STAFF REPORT
COMMUNITY DEVELOPMENT DEPARTMENT

HEARING DATE: 12/2/2021
 TO: Planning & Zoning Commission
 FROM: Joe Dodson, Associate Planner
 208-884-5533
 SUBJECT: H-2021-0071
 Lennon Pointe Community
 LOCATION: The site is located at 1515 W. Ustick Road, in the southeast corner of N. Linder Road and W. Ustick Road, in the NW ¼ of the NW ¼ of Section 1, Township 3N., Range 1W.

- Annexation of 10.41 acres of land with a request for C-C (2.01 acres) and R-15 (8.3 acres) zoning districts;
- Preliminary Plat consisting of 44 residential building lots (43 single-family residential and 1 multi-family residential), 1 commercial building lot, and 2 common lots on 8.8 acres of land in the proposed C-C and R-15 zoning districts;
- Conditional Use Permit for a multi-family development consisting of a total of 18 units on 1.18 acres in the proposed R-15 zoning district, by DG Group Architecture, PLLC.

OVERALL LANDSCAPE PLAN

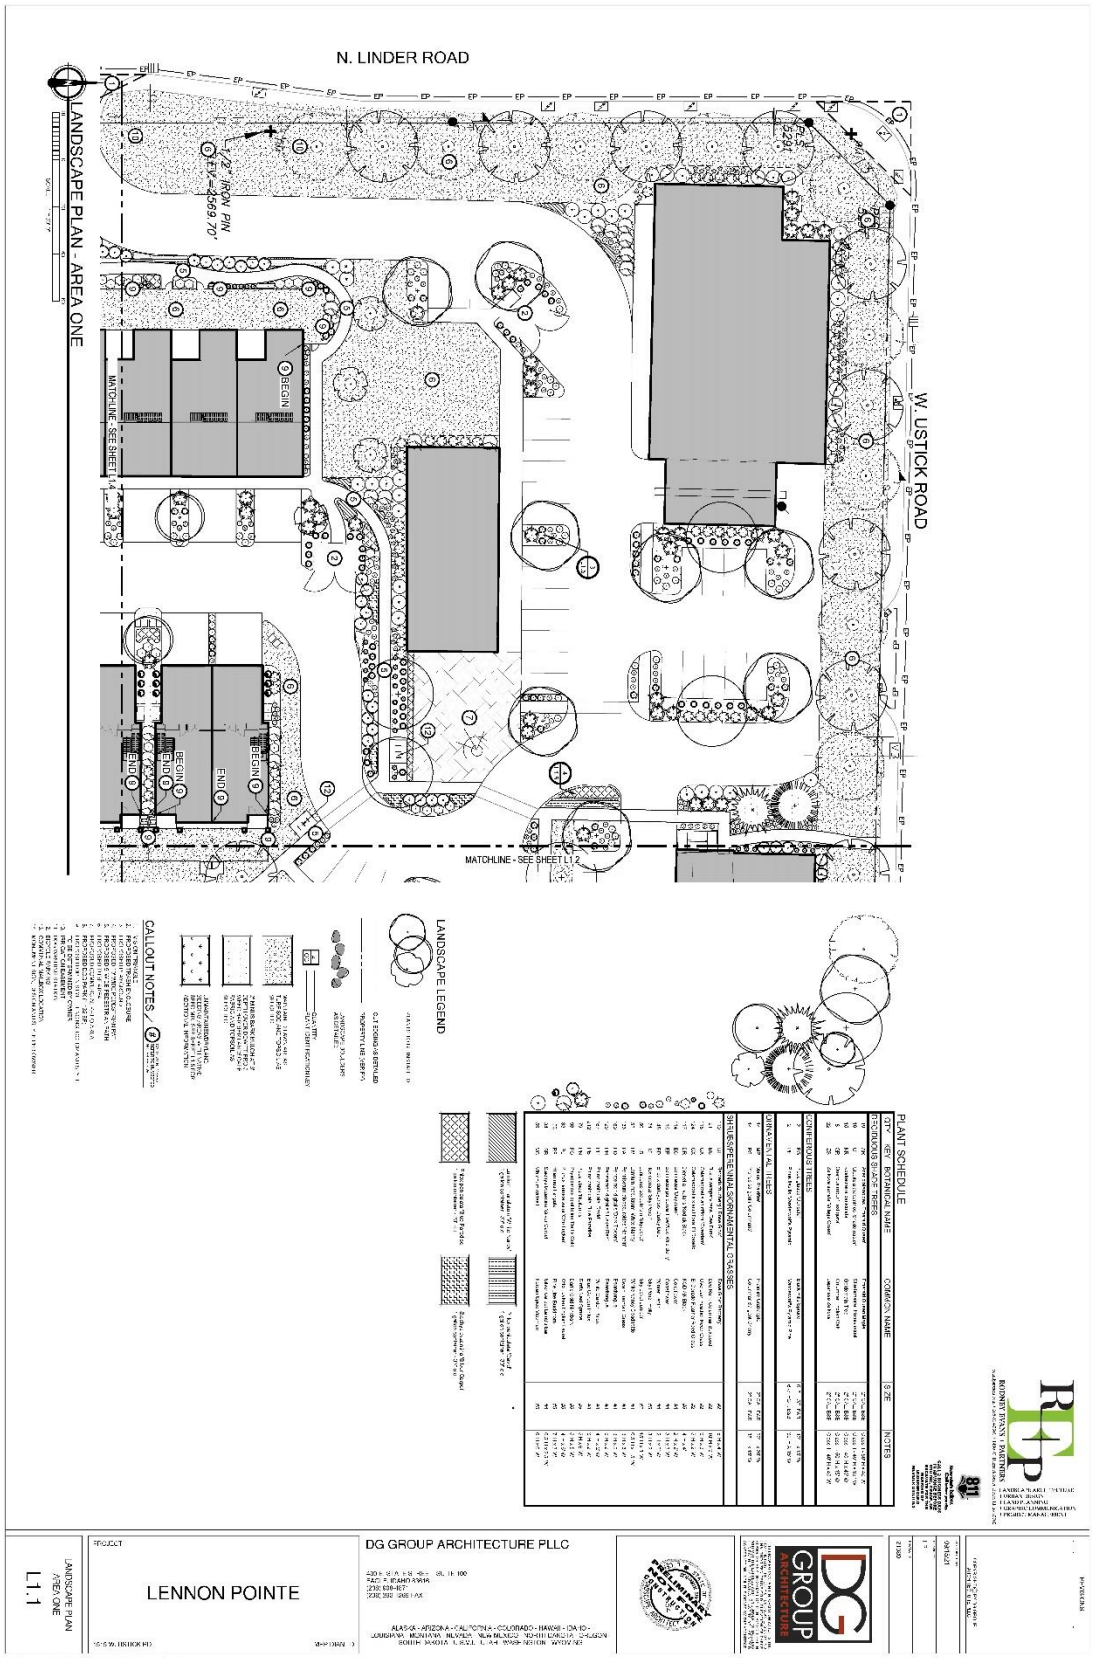
*In addition, an area of the Creason Lateral and Kellogg Drain irrigation easements underlay a large portion of the landscape buffer along Linder Road that is currently shown with trees. Staff anticipates the applicable irrigation district will not allow trees within their easements so the landscape plans should be revised to show the removal of trees from the easement area. Furthermore, code requires that if a required landscape buffer is encumbered by easements, at least 5 feet of landscaping be proposed outside of the easement area to include the required number of trees. **Because of the extensive impediment these two irrigation facilities create in this area of the site, Staff does not find it feasible to comply with this code requirement in its fullest extent as it would require half of the site to shift to the east reducing the width of the new in the center of the development. Staff finds the trees that are allowed outside of the easement area, the placement of the access point to Linder, and the separation of the townhome units from Linder offer appropriate and adequate landscaping and buffering. However, to formalize this finding and comply with code, the Applicant should apply for Alternative Compliance with the first final plat application.***

According to the submitted landscape plans, the proposed regional pathway in the southwest corner of the site is also within the Kellogg Drain irrigation easement which generally does not allow trees and minimal landscaping. The submitted landscape plans show no trees proposed within this easement.

According to the submitted plans, a 20-foot buffer is proposed to be shared over the commercial property boundary – 10 feet on the commercial property and 10 feet on the residential side. It appears the additional required 5 feet of area can be easily accommodated and will not require any revision to the placement of buildings. In addition, in order to allow the commercial site to be more viable and the fact the proposed development is planned together, Staff approves of the proposal to share the width of the 25-foot landscape buffer across the shared property line.

- a. Revise the location of the trees for the Linder Road street buffer to be outside of any waterway easement.
 - b. Shift the proposed regional pathway on Lot 1, Block 1 to the west to better align with the approved segment to the south in Creason Creek No. 2.

- c. Show the required 25-foot landscape buffer between the C-C zoning district and the R-15 zoning district as required by UDC 11-3B-9C.
4. The site plan, as shown in Exhibit VII.E, shall be revised as follows prior to Final Plat submittal:

E. Site Plan

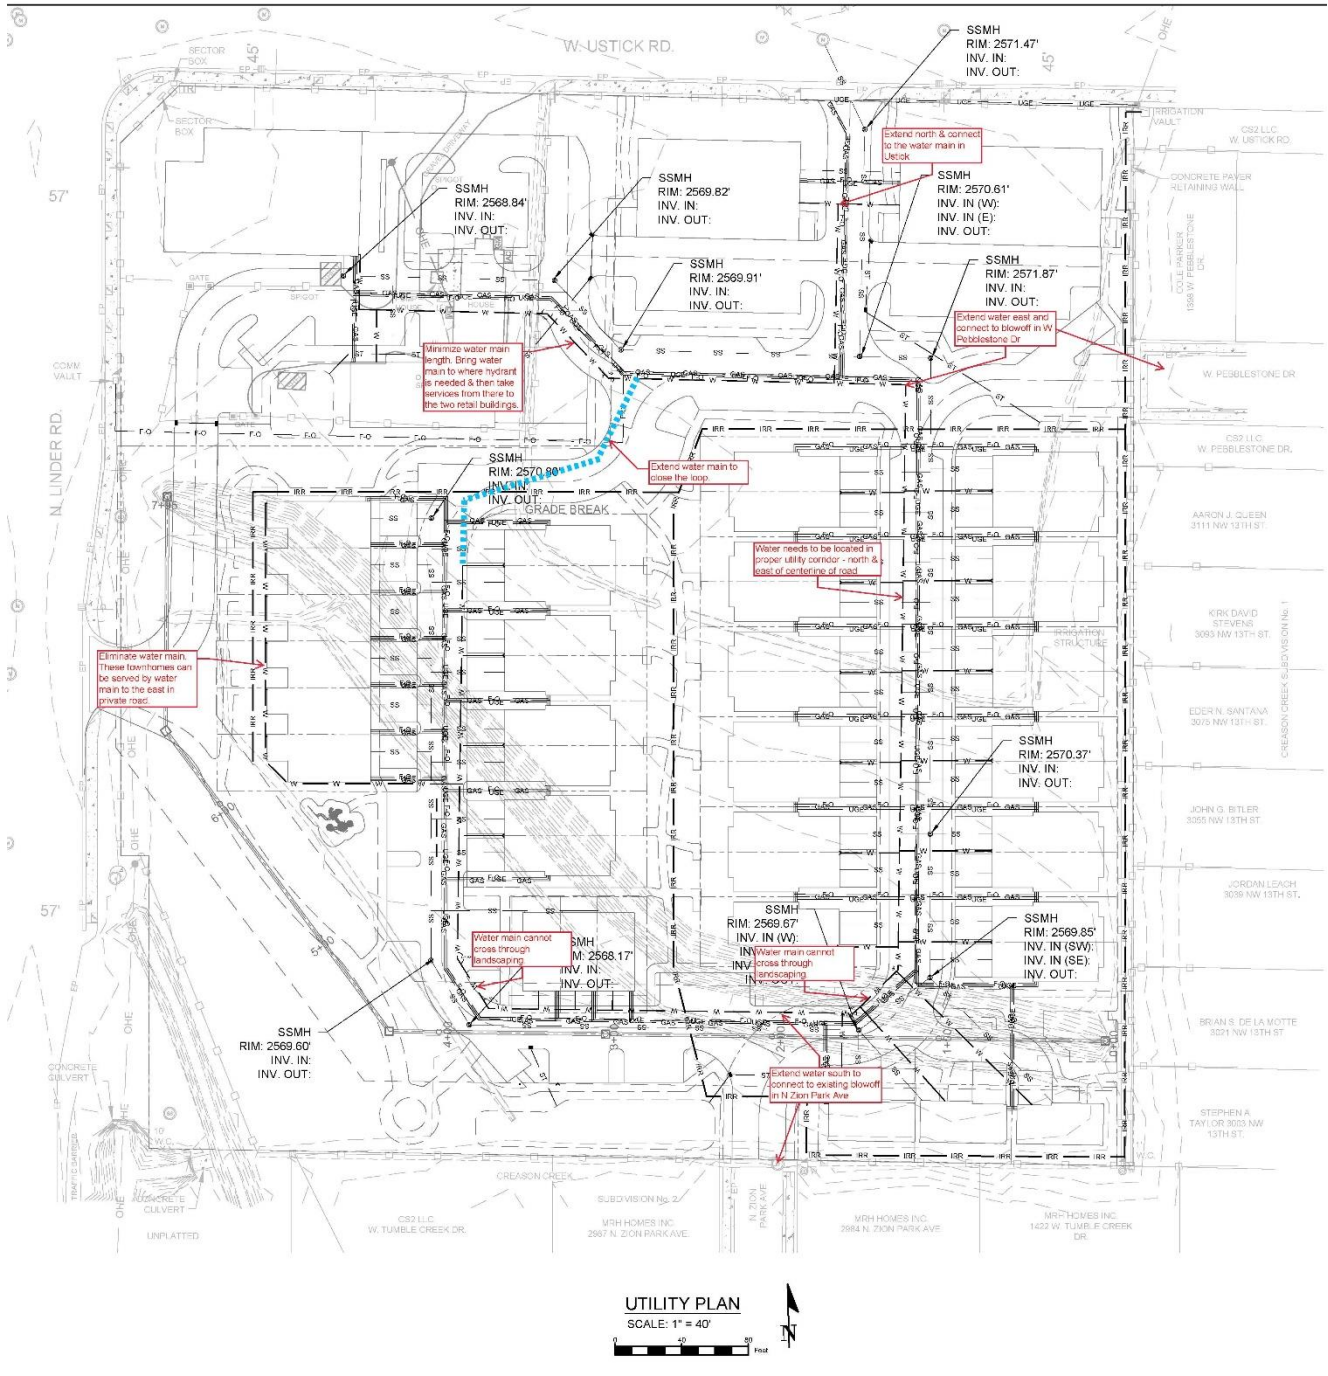
Furthermore, it appears the site plan shows building footprints too large for the proposed building lots—the building footprints do not meet the minimum building setback to the entrance sidewalks of 10 feet. When future building permits are submitted, the Applicant will be required to show compliance with all R-15 dimensional standards as outlined in [UDC Table 11-2A-7](#).

The commercial area proposed in the northwest corner of the site is shown with two buildings totaling approximately 12,000 square feet requiring at least 24 parking spaces based on the nonresidential parking ratio of 1 space for every 500 square feet of commercial gross floor area. *According to the submitted site plan, 25 parking spaces are being proposed. Each space appears to meet the minimum dimensional standards of 9' x 19' as well. Complete analysis of the proposed commercial area will take place with the first CZC application for the commercial site. Initial analysis shows compliance with all UDC dimensional standards except for how the drive aisle along the north and east of the commercial site functions. The drive aisle along the north boundary of the site is shown as 12 feet wide which implies a one-way drive aisle and it leads to the drive aisle along the east boundary of the site that is shown as approximately 26 feet wide which implies two-way traffic. There does not appear to be a need for the eastern drive aisle to allow two-way traffic if the north drive aisle is a one-way exit in this area.*

- c. Show the required number of covered spaces for the proposed multi-family residential development, per UDC Table 11-3C-6.
 - d. Shift the proposed regional pathway on Lot 1, Block 1 to the west to better align with the approved segment to the south in Creason Creek No. 2.

F. Public Works – Water Markup

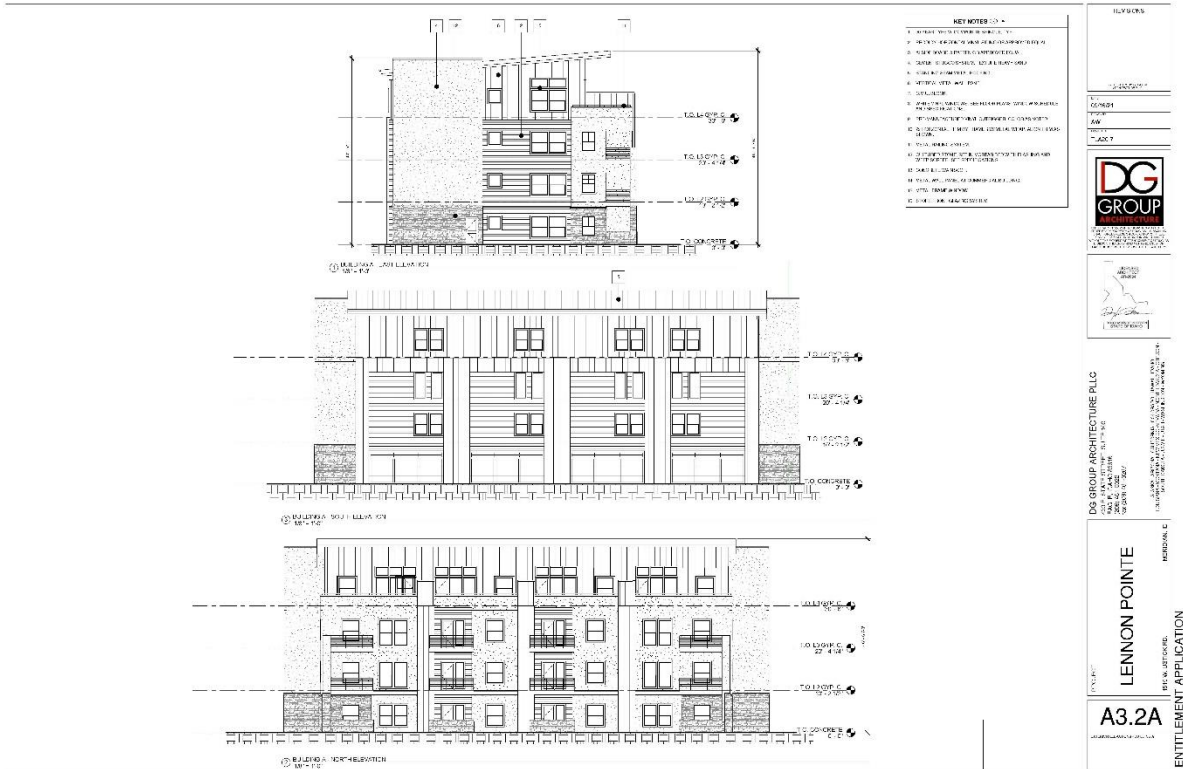
8. Minimize water main length near the commercial lot at the northwest corner of the development. Bring the water main only as far as needed to provide a hydrant for the buildings' fire protection. Extend service lines from the main to serve the two retail buildings.

G. Conceptual Building Elevations and Site Renderings

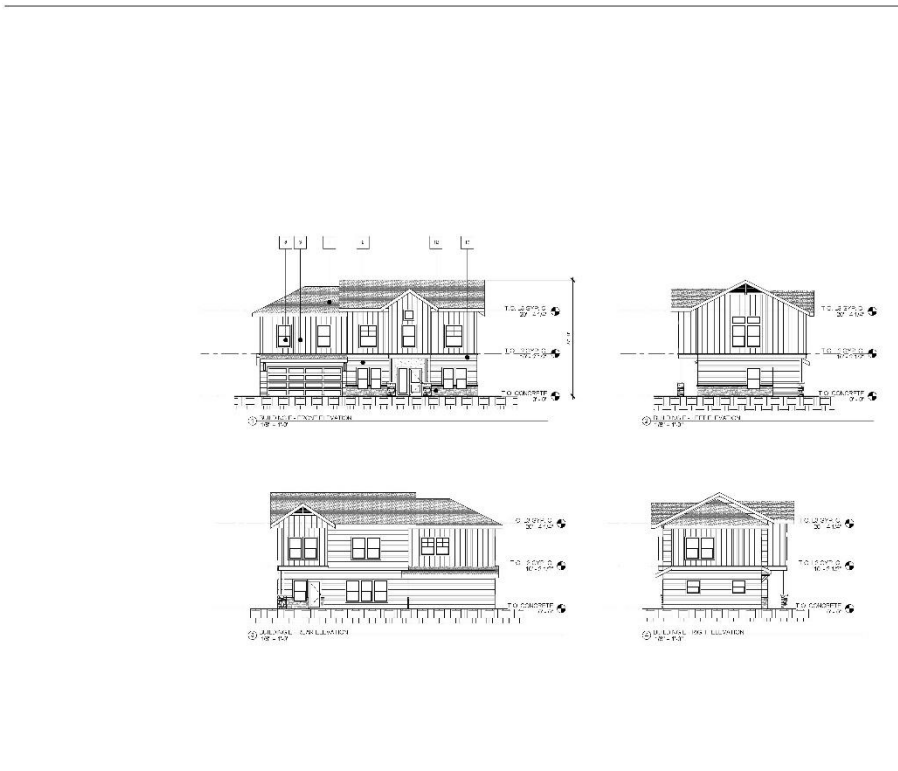
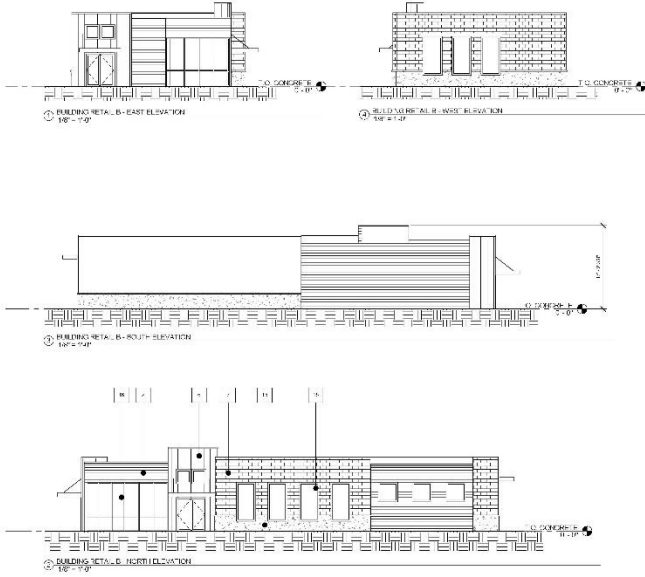
However, the one area of the site that Staff finds could provide more transition is the 4-story multi-family building along Ustick that is also adjacent to single-family to the east. The existing detached single-family home in Creason Creek directly adjacent to the site is a single-story home

with an upstairs bonus room. Despite the separation of the side yard of the single-family home and a proposed micro-path area of 20 feet wide between the two uses, Staff finds the height disparity of the existing home and the proposed 4-story multi-family building is an adequate transition. According to the Applicant, the multi-family units are each two stories and are being proposed as being stacked, which is how the 4-story concept is proposed. Therefore, Staff is recommending the top two (2) units directly adjacent to Creason Creek are removed so there is approximately 65 feet (includes landscaping and unit width) of separation between the existing home and the 4-story portion of the multi-family. With this revision, the height of the two story multi-family units would be approximately 21 feet depending on how the Applicant proposes to roof the units (flat roof or pitched roof).

According to the submitted conceptual elevations, the proposed 4-story multi-family buildings are 46 feet in height which is above the 40 foot height limit for the requested R-15 zoning district. Prior to submitting for CZC and Design Review, the Applicant is required to correct this to comply with the R-15 dimensional standards.

5. The multi-family residential elevations, shall be revised as follows at least ten (10) days prior to the City Council hearing:
 - a. Reduce the height of the proposed buildings to meet the maximum building height limit of forty (40) feet for the R-15 zoning district.

- b. Show the loss of the two units on the third and fourth levels of the eastern multi-family building consistent with the DA provision above.
6. With Final Plat application, the Applicant shall submit for Alternative Compliance to the landscape street buffer tree requirements along N. Linder Road for that area encumbered by the Kellogg Drain and Creason Lateral easements.
